SITE PLAN SUBMITTAL - HAC SCG DIV 48 BLDG S75

ADMINISTRATIVE AMDT. 4-22-87
REVISE DIMENSIONS OF PARKING LOT LIGHT
STANDARD CONCRETE BASE AND METAL
POLE LENGTH
2. REVISE MAXIMUM HEIGHT OF ROOF
SCREEN FROM 15' TO 12'
ADMIN AMDT 1986-6069-05 09-21-04
34. Extend screen wall around new chiller
ADMIN. AMDT 1986-6069-05 02-26-07
35. DELETE 2 PARKING SPACES & ADD SIDEWALK
TO NEW CROSSWALK

MINOR SITE PLAN AMENDMENT

RAYTHEON S75
INFRASTRUCTURE UPGRADES
16800 E. CENTRETECH PARKWAY
AURORA, CO 80011

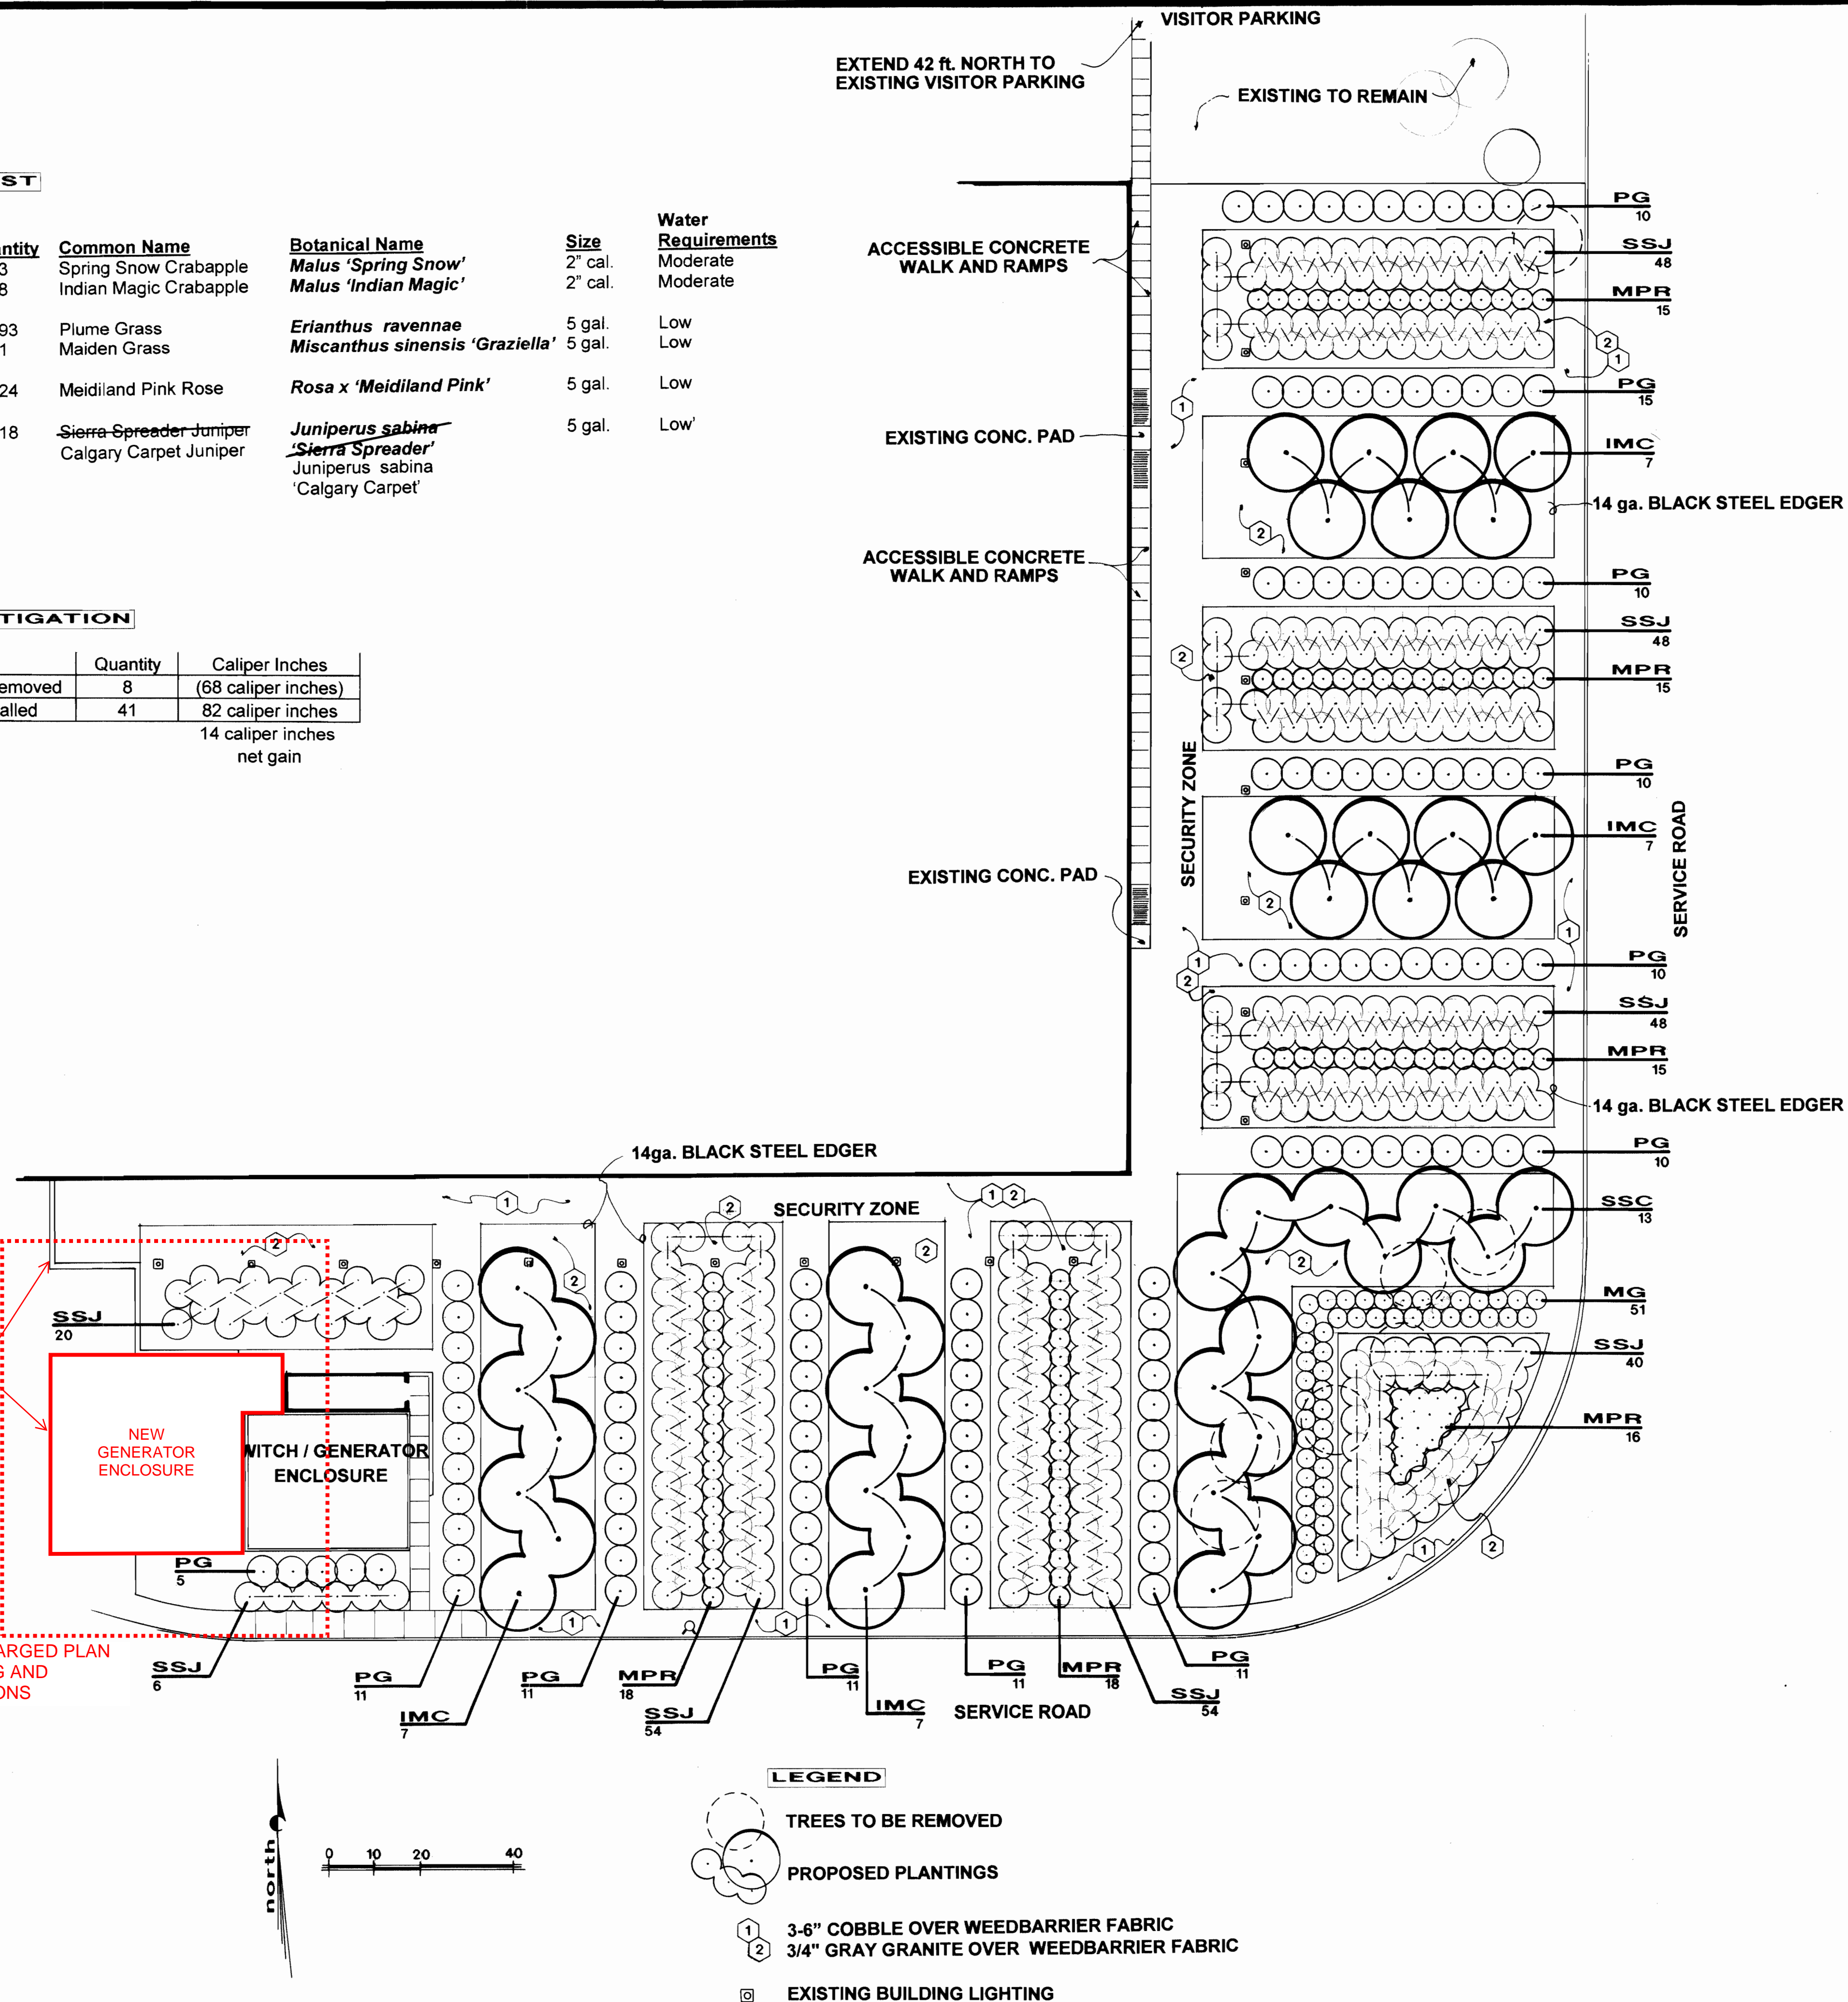
APPROXIMATE FOOTPRINT OF THE NEW GENERATOR ENCLOSURE DIRECTLY WEST OF EXISTING GENERATOR ENCLOSURE AT SOUTH SIDE OF THE BUILDING.

THE NEW GENERATOR ENCLOSURE WILL EXTEND TO THE WEST AND ALIGN WITH THE WEST FACE OF THE EXISTING BUILDING.

THE NEW GENERATOR ENCLOSURE WILL HAVE A SIMILAR AESTHETIC TO MATCH THE EXISTING ENCLOSURE.

ARCHITECTURAL - ENLARGED
GENERATOR ENCLOSURE AND
EXTERIOR STAIR PLANS

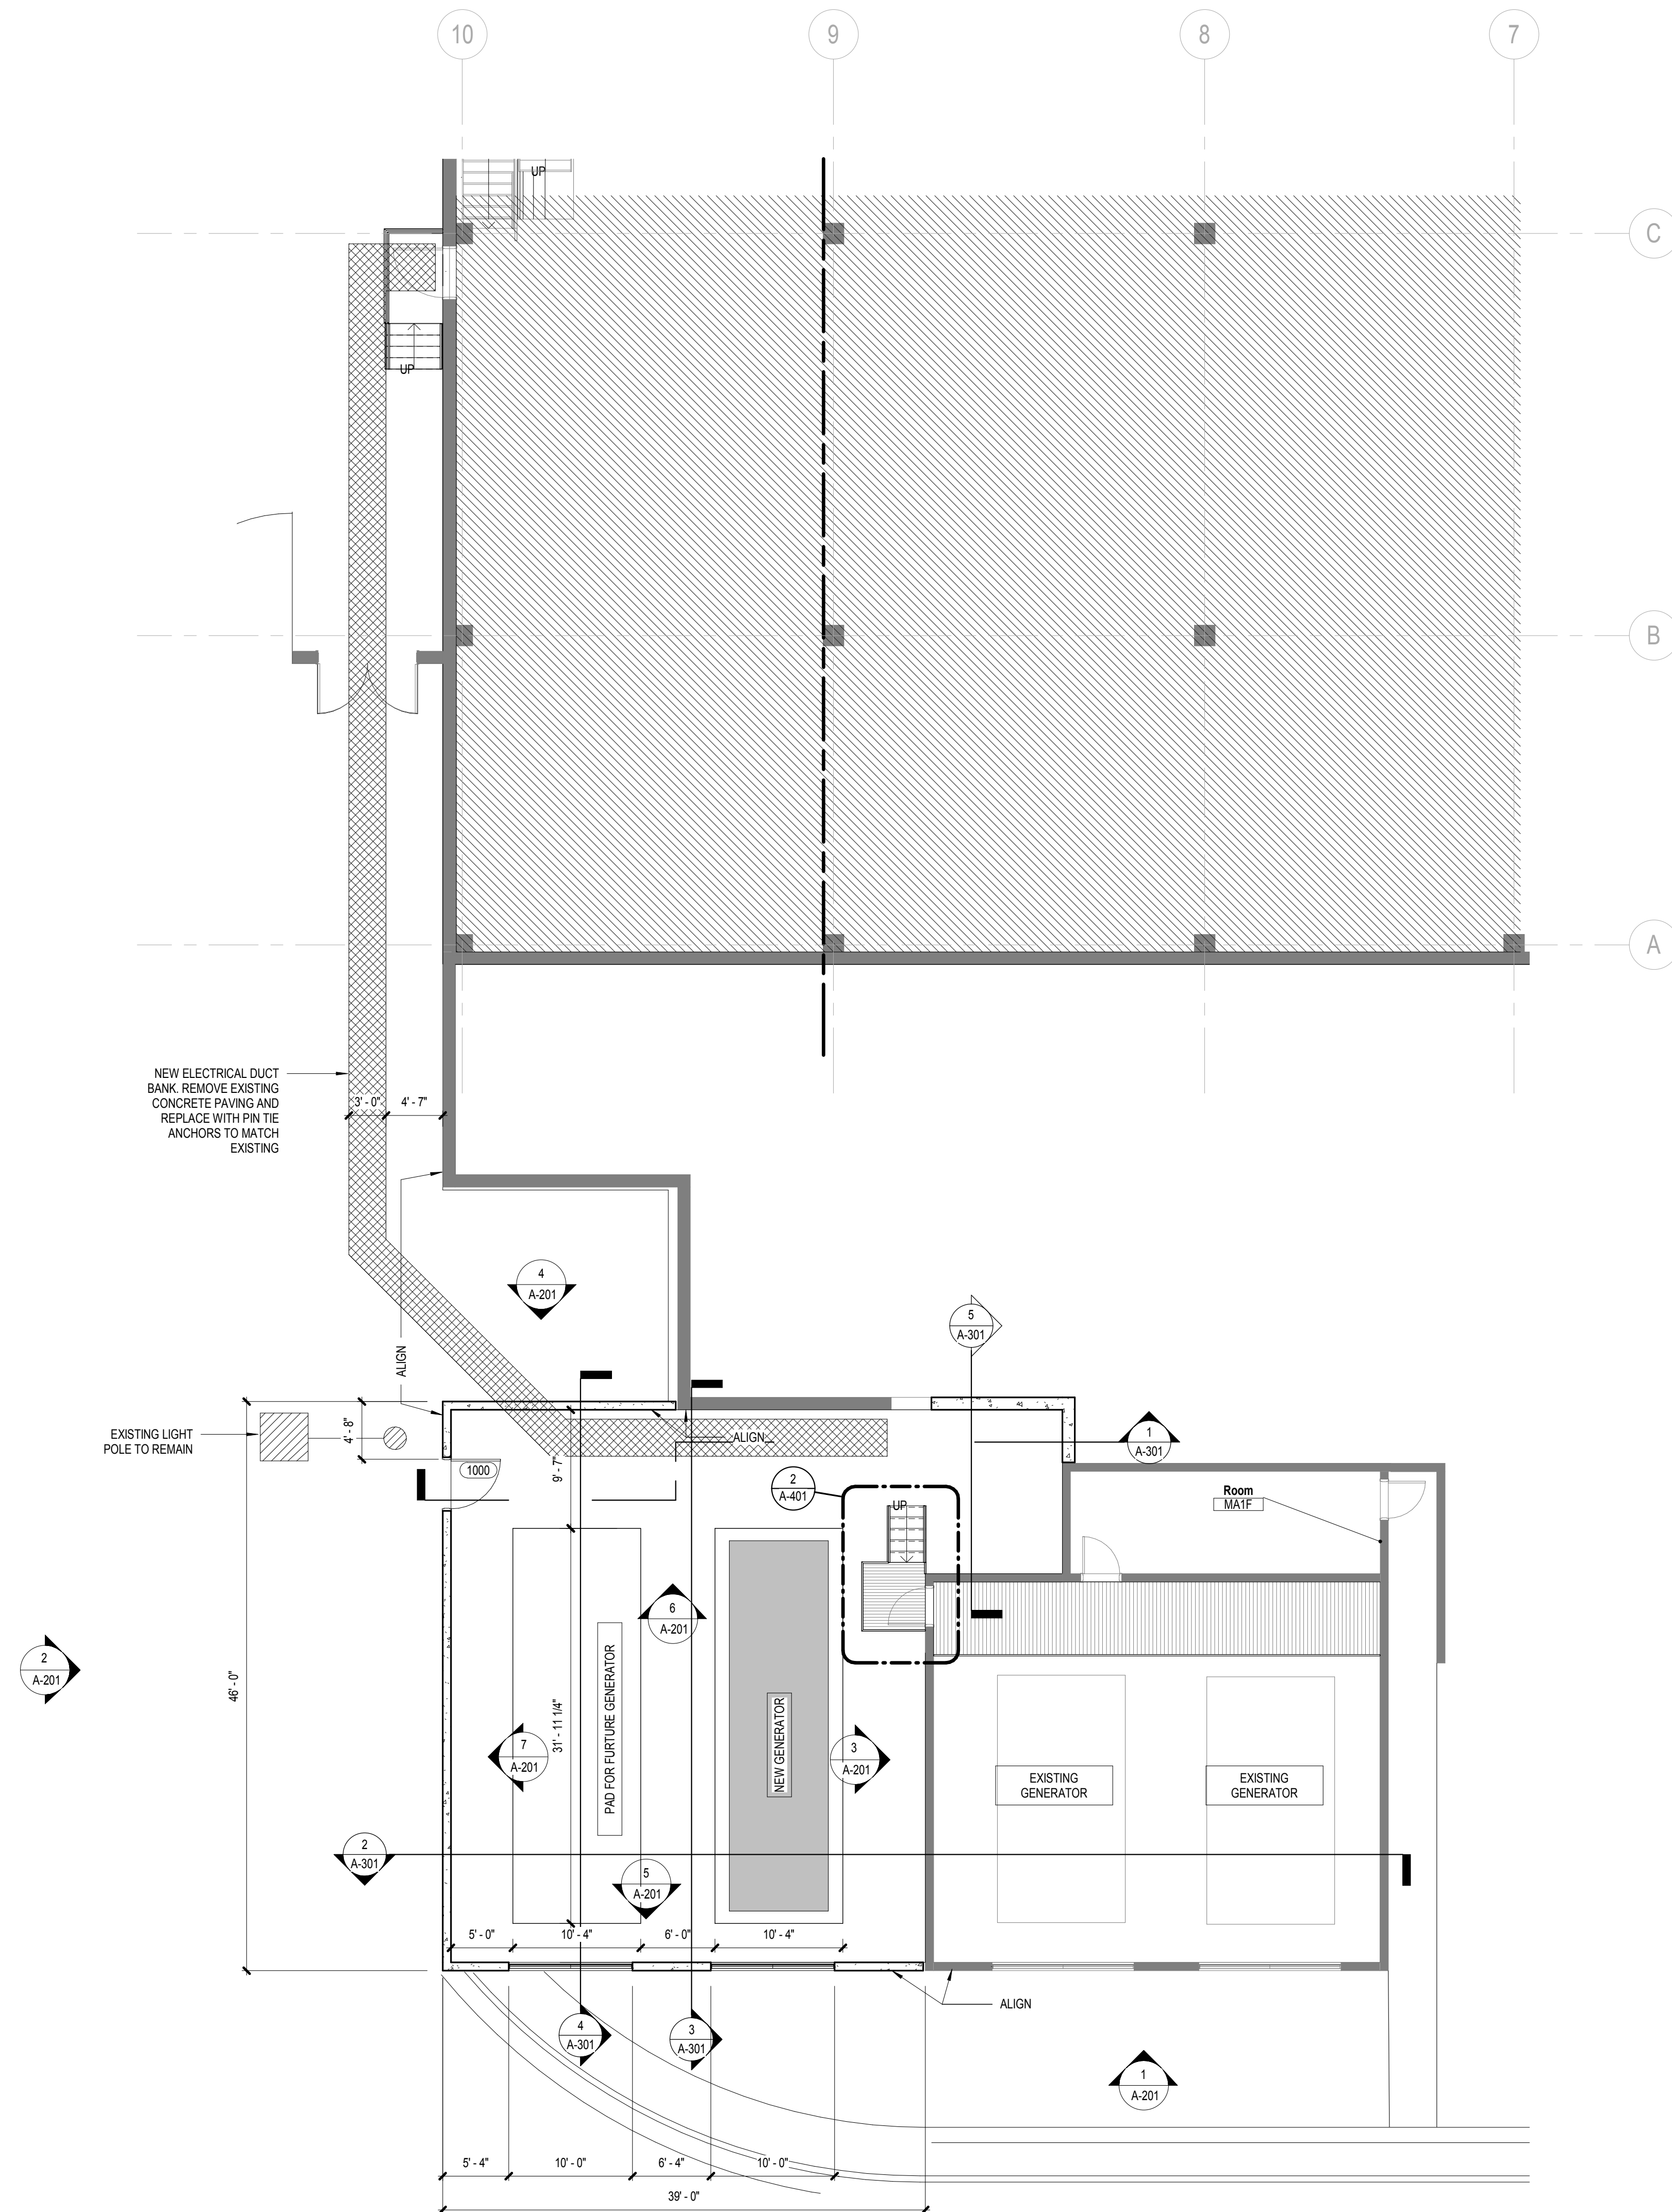
NEW GENERATOR ENCLOSURE, AESTHETICALLY SIMILAR TO EXISTING ENCLOSURE AND ADJACENT WALLS

NEW VERTICAL PAINTED METAL SCREEN BLADES AESTHETICALLY SIMILAR TO EXISTING

NEW CONCRETE WALLS, FINISH TO MATCH EXISTING
